# TOWN OF CORTLANDT PLANNING BOARD

**MEETING AGENDA.....PLANNING BOARD  
TOWN OF CORTLANDT  
6:30 THURSDAY EVENING\*  
OCTOBER 7, 2025**

**PB 2023-5** a. Letter dated September 29, 2025 from David Steinmetz, Esq. requesting the 7<sup>th</sup>, 90-day time extension of Final Plat Approval for the Evergreen Subdivision located at 2003 Crompond Road.

SP-8.1

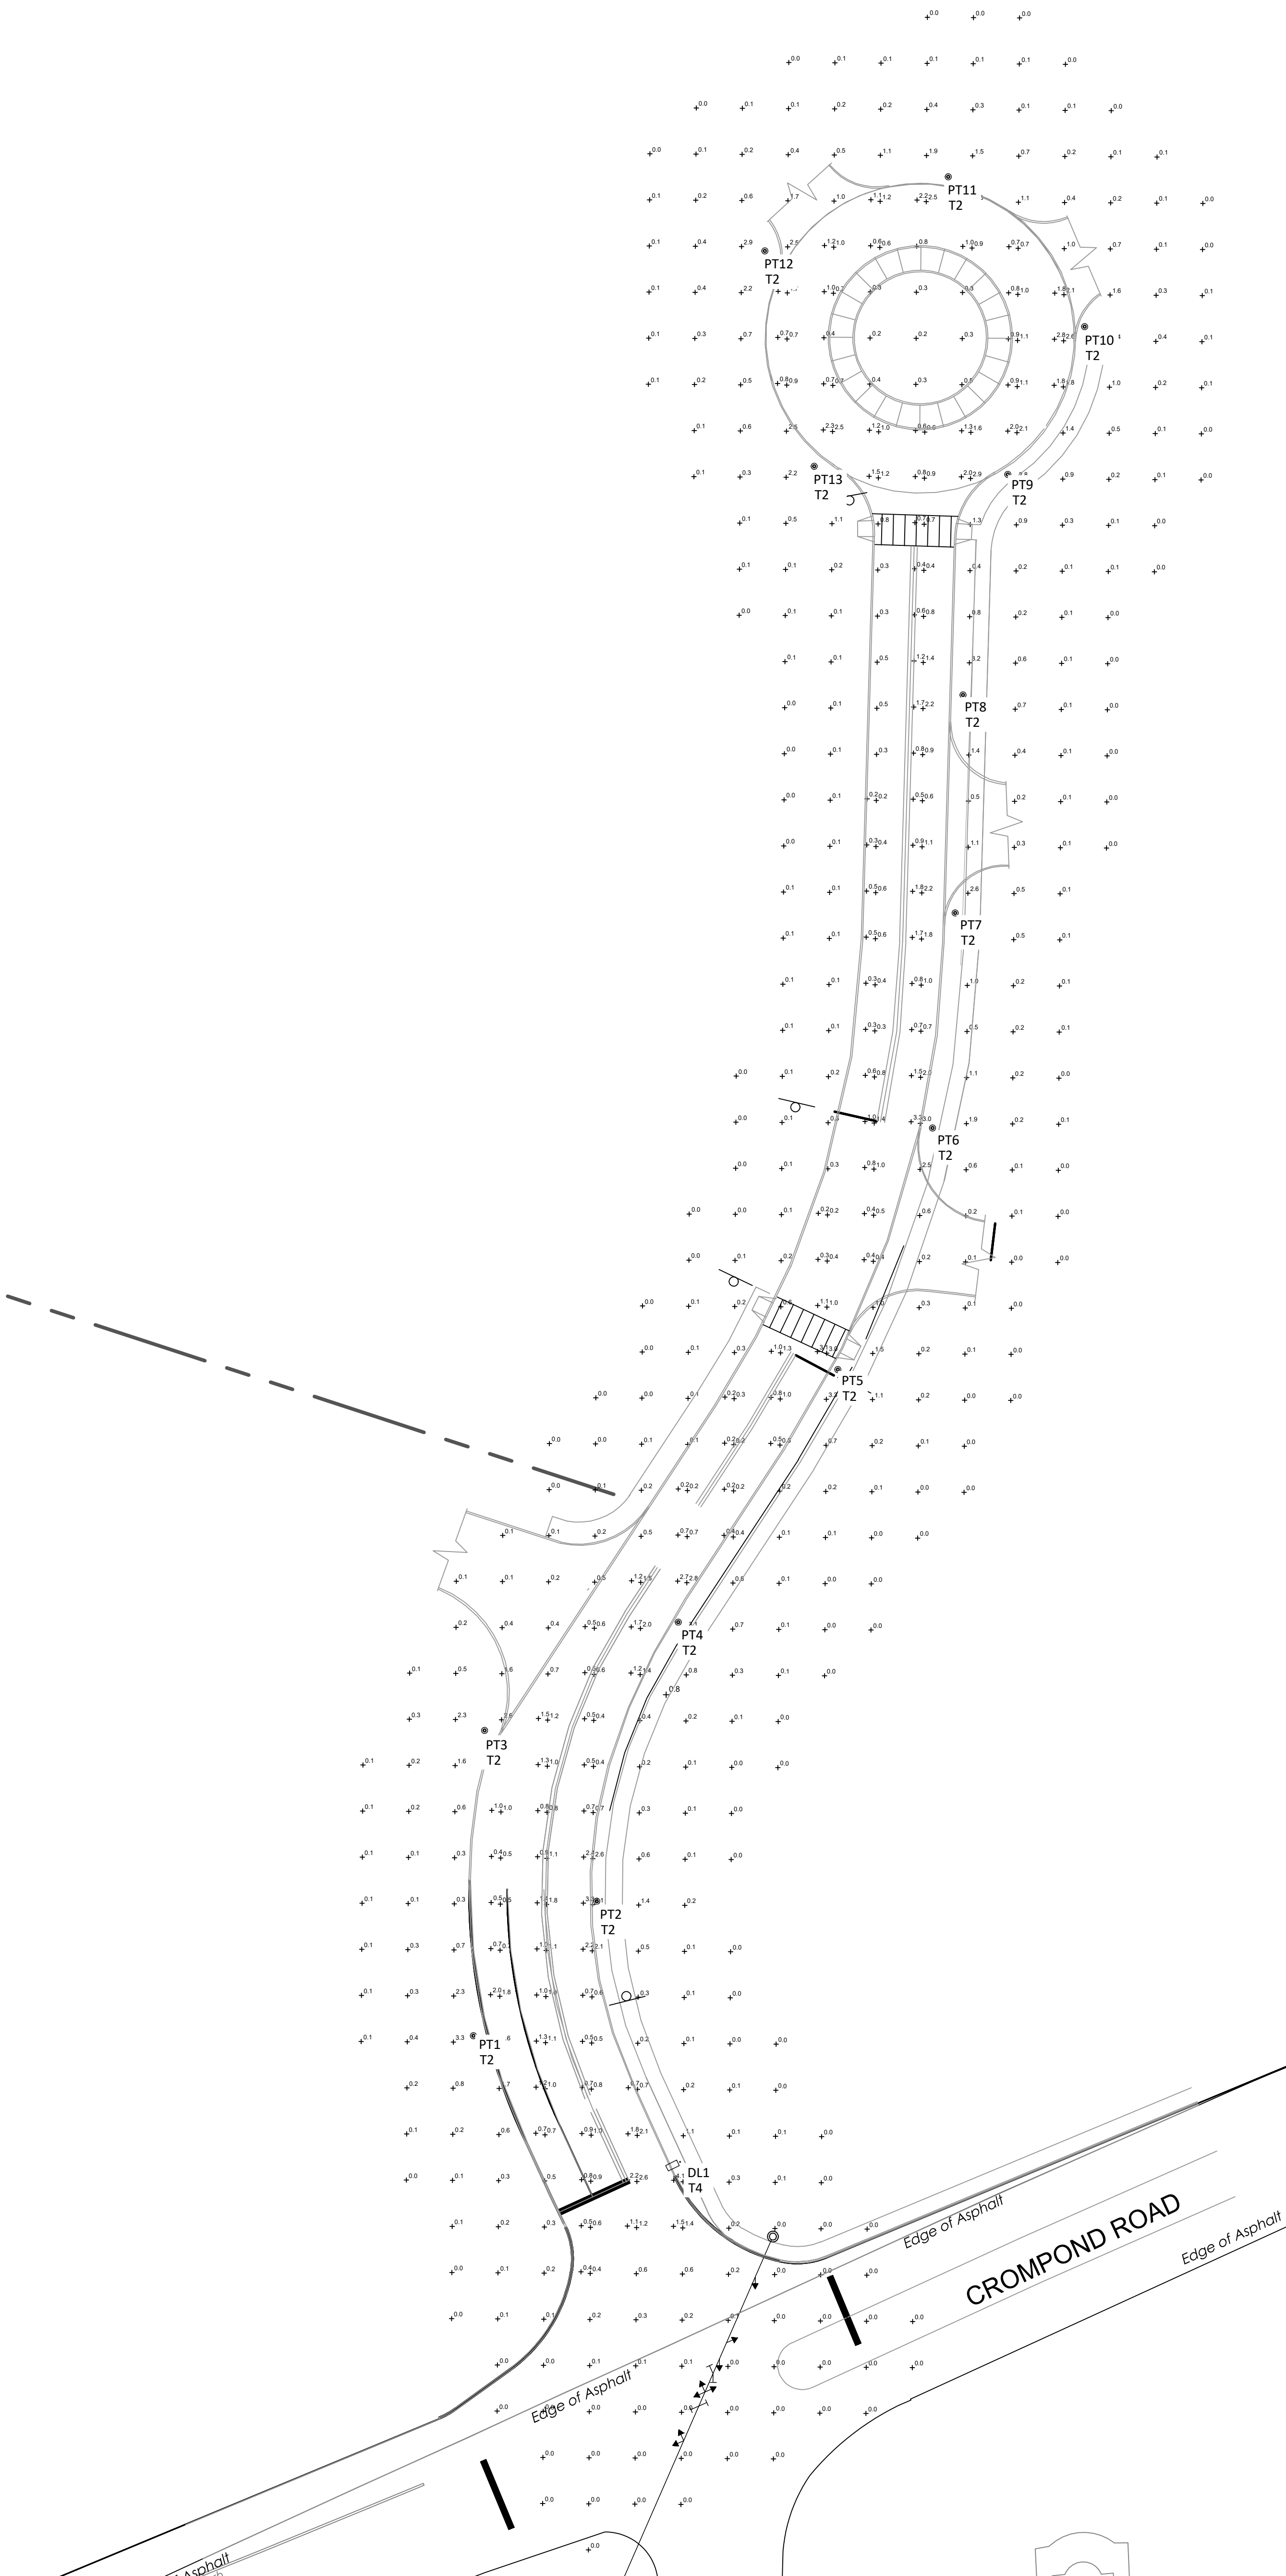
87.     *Comment:*        *SP-8.1 – Provide a Pre-Construction Erosion and Sediment Control Plan which identifies the measures to be in place prior to construction initiation.*  
          *Response:*      A construction sequence has been added to the Erosion and Sediment Control Plan which incorporates measures to be in place prior to the start of construction. Additional notes have also been provided to identify the required practices during initial site preparation.

88.     *Comment:*        *SP-8.1 – Provide silt fencing at the end of the cul de sac and along the northern limit of disturbance to protect wetland areas.*  
          *Response:*     Silt fencing has been added at the end of the cul-de-sac and along the northern limit of disturbance to protect the adjacent wetland areas.

89.     *Comment:*        *SP-8.1 – Provide Silt fencing along the DOT ROW*  
          *Response:*     Silt fencing has been added along the DOT right-of-way as requested.

90.     *Comment:*        *SP-8.1 –Provide inlet protection on all catch basins and drain inlets.*  
          *Response:*     Inlet protection has been shown on the Erosion and Sediment Control Plan.

91.     *Comment:*        *SP-8.1 – Provide a construction sequence.*  
          *Response:*     A construction sequence has been added to the Erosion and Sediment Control Plan and is included in the revised plan set submitted herewith.

92.     *Comment:*        *SP-8.1 – Place the following note from the Preliminary SWPPP for the project on this plan:*  
                              *In the event that colloidal soils are encountered during construction that cannot be settled out through typical erosion control measures, the sediment trap outlets will be modified to allow manual operation. Stormwater runoff will be retained in the sediment traps to allow the colloidal soils to settle out. Prior to forecasted storm events, the retained stormwater will be released at a controlled rate through a filter to provide capacity for the next storm. Flocculants may not be used without prior approval from the NYSDEC.*  
          *Response:*     The requested note has been added to the plan.
